# Access Compliance Report

## Public Rights-of-Way

Intersection ID: 27610	Main Street: JOHNSTON_RD	Cross Street: JOHN_J_DELANEY_DR	Location: SW
ADA ID: 6F309E6CA4F4	Ramp Type: BlendTrans2	Initial Pass/Fail: Pass	Overall Compliance: No
Severity Score: 10			
Codes/Mitigation Info/Possible Solution		Field Measurements/Component Compliance

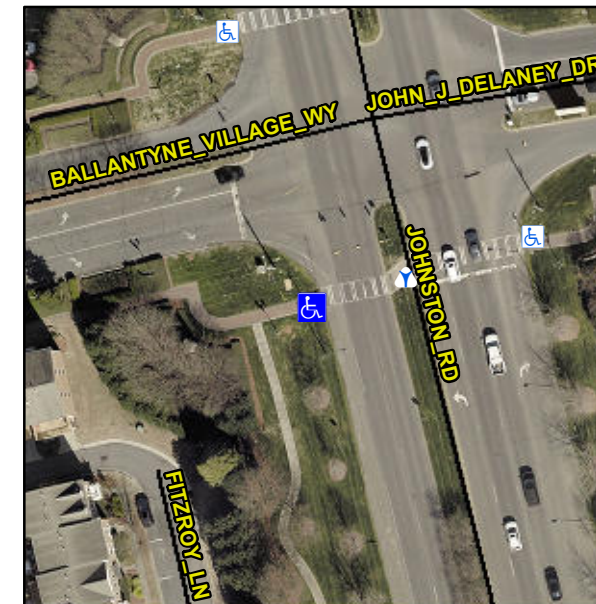
**Install Detectable Warning System.**

**NO CURB**

**R305**
